UNITED STATES PATENT AND TRADEMARK OFFICE

APPLICATION NO.	FILING DATE	FIRST NAMED INVENTOR	ATTORNEY DOCKET NO.	CONFIRMATION NO.
10/041,832	10/19/2001	Robert Dale Haun	DEE6270P0130US	4546
7590	06/03/2004		EXAMINER	
The Law Office of Randall T. Erickson, P.C. 425 W. Wesley St. Suite 1 Wheaton, IL 60187			BOTTORFF, CHRISTOPHER	
			ART UNIT	PAPER NUMBER
			3618

DETAILED ACTION

Fig. 4

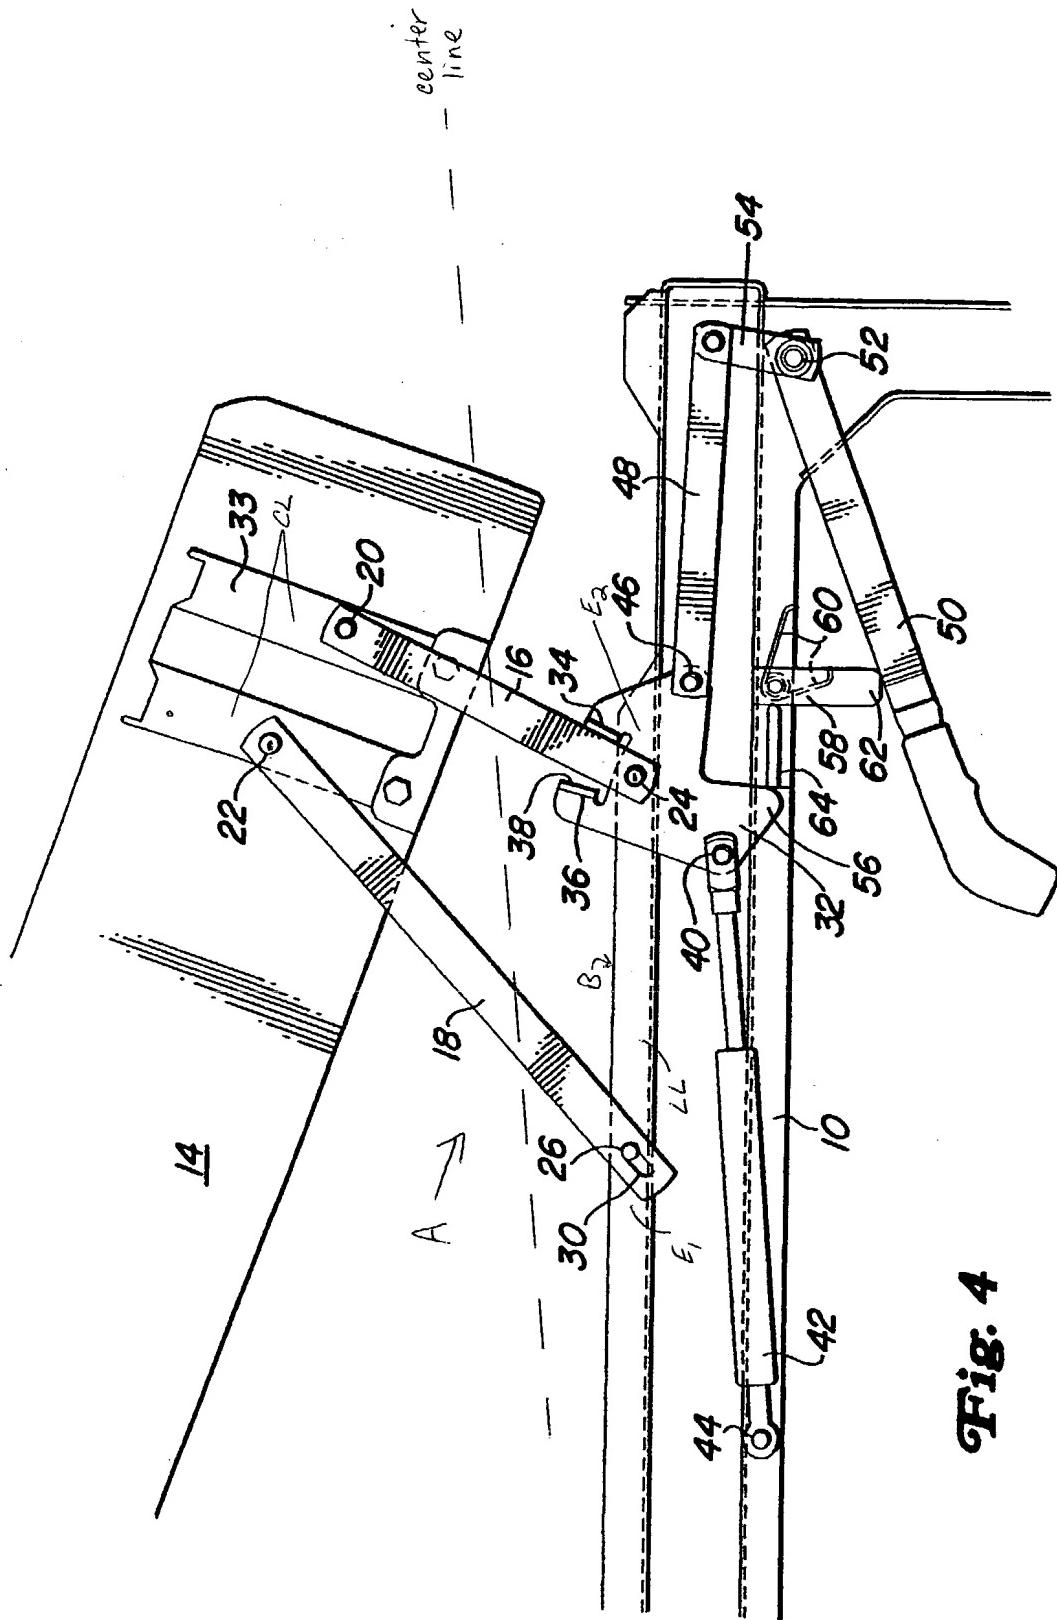
Esau et al. discloses a hinge assembly A (note the reference numerals added to the attached copy of Figure 4) comprising a double-rocker, four link mechanism. A hood-mounted bracket 23 comprises one link and is mounted to an underside of a tractor hood 14, near a back end of the tractor hood. The hinge allows the hood to open upwardly and backwardly from the front end of the tractor. See column 1, line 63, through column 2, line 2; and Figures 1-3.

The double-rocker, four link mechanism includes a lower, fixed link LL (note the reference numerals added to the attached copy of Figure 4) having two opposite ends E1, E2 (note the reference numerals added to the attached copy of Figure 4). Fixed link LL forms a bracket B (note the reference numerals added to the attached copy of Figure 4) and, consequently, each end of the fixed link is defined by a body bracket B mounted

to the tractor body. The mechanism further includes an upper, coupler link CL (note the reference numerals added to the attached copy of Figure 4) defined by a portion of the hood mounted bracket and formed by a central region of the bracket. The coupler link has two opposite ends. Two rocker links 16, 18 are provided that each has a lower end connected pivotally to one of the opposite ends of the fixed link at pins 24 and 26 respectively and an upper end connected pivotally to one of the opposite ends of the coupler link CL at pins 20 and 22 respectively. The rocker links are comprised of a comparatively longer, front link 18 and a comparatively shorter, back link 16, and wherein the coupler link CL is the shortest link. Also, the front 18, back 16, and coupler links CL are displaceable so that the upper end of the back link is movable toward and away from the lower end of the front link, between positions on opposite sides of a center line drawn between the lower end of the back link and the other end of the coupler link.

Figures 2 and 4 of Esau et al. is drawn between the lower end of the back link and the first end of the coupler link, and the upper end of the back link is movable between positions on opposite sides of the centerline. Applicant's illustration depicts the centerline as intersecting specific points on the lower end of the back link and the first end of the coupler link, but such intersection is not required by the claims.

Fig. 2

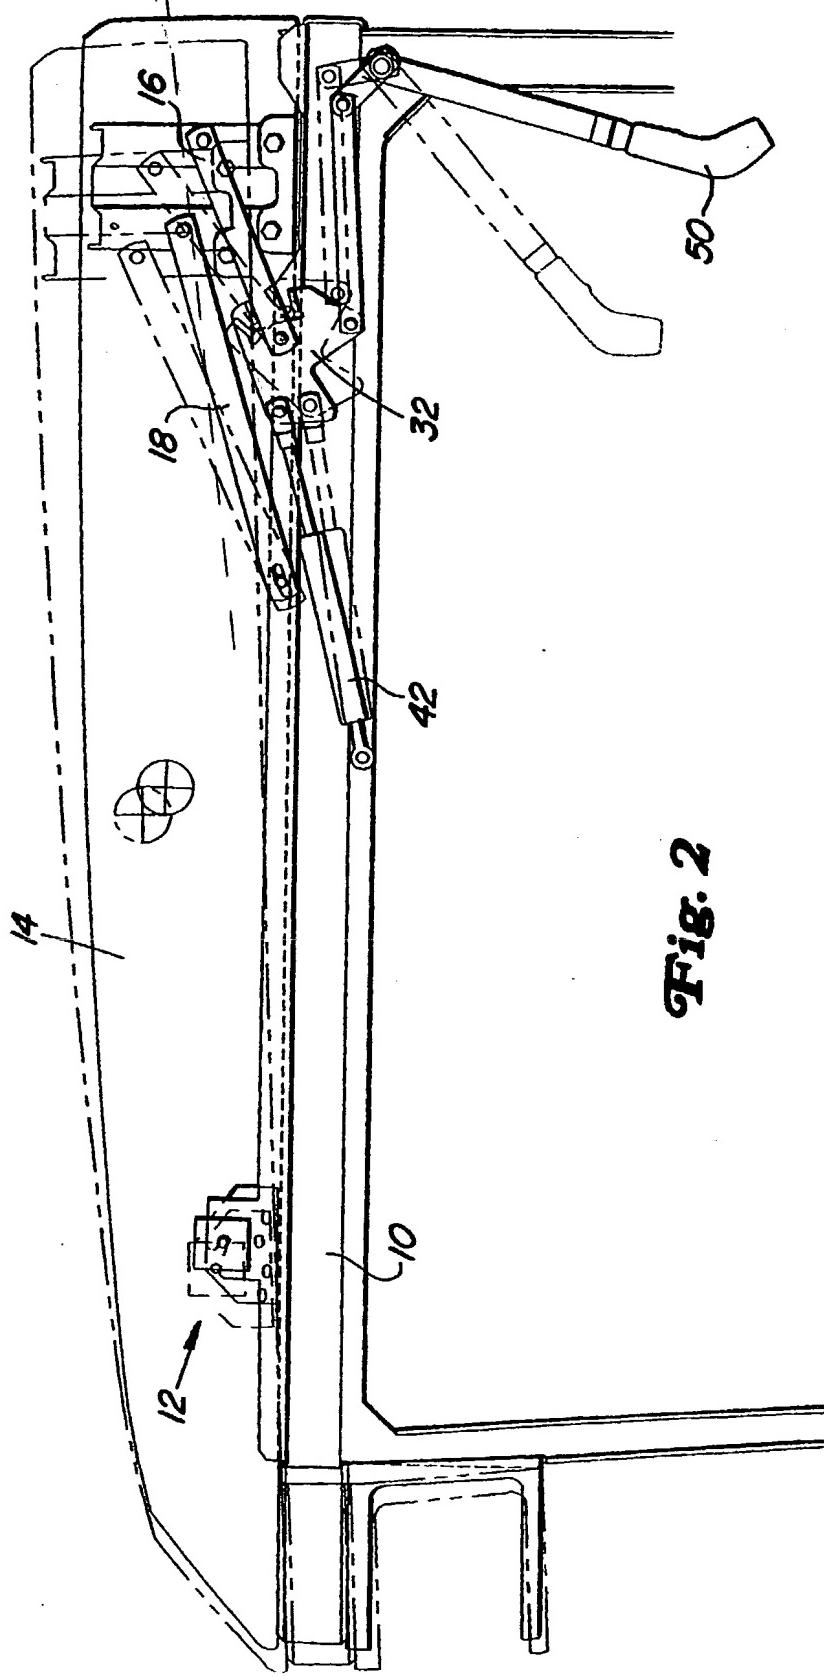
The arguments included a marked up copies of Figures 2 and 3 of the present application to illustrate the claimed "centerline." Although the centerline depicted by Applicant would satisfy the definition in the claims, numerous other centerlines would also satisfy the definition in the claims. The attached marked up copies of Figures 2 and 4 of Esau et al. illustrate a centerline that satisfies the definition in the claims. Claim 1 states that the centerline is "drawn between the lower end of the back link and the first end of the coupler link." The centerline illustrated in the marked up copies of
